## Technical product information

<b>Topic</b>	Owner's Handbook - Incorrect roof console image shown - Garage Door Opener (GDO)
<b>Market area</b>	Bentley: worldwide (2WBE)
<b>Brand</b>	Bentley
<b>Transaction No.</b>	2062075/1
<b>Level</b>	EH
<b>Status</b>	Approval
<b>Release date</b>

### Bentayga - W12 and V8 Kovomo only

Figure 1

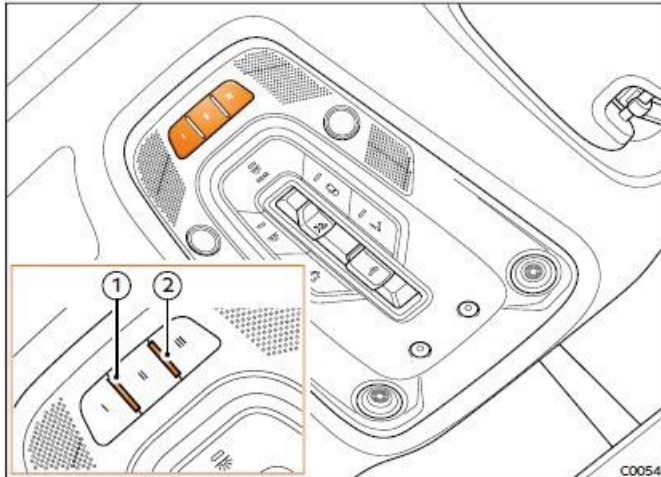
The Owner's Handbook is showing an incorrect roof console image, highlighting the Garage Door Opener (GDO) programming switches for Bentleyga 21MY vehicle derivatives

The image shown in Figure 1 has been removed from the Controls and Interior Features chapter of the Owner's Handbook

▪ The GDO switches are no longer fitted in the roof console and all functionality is controlled within the Infotainment system.

The configuring of the Garage Door Opener can be now achieved by accessing the following area of the Infotainment system and by following on-screen guidance:

- Setting and service - Garage door opener - *(when fitted)* configure the garage door opener
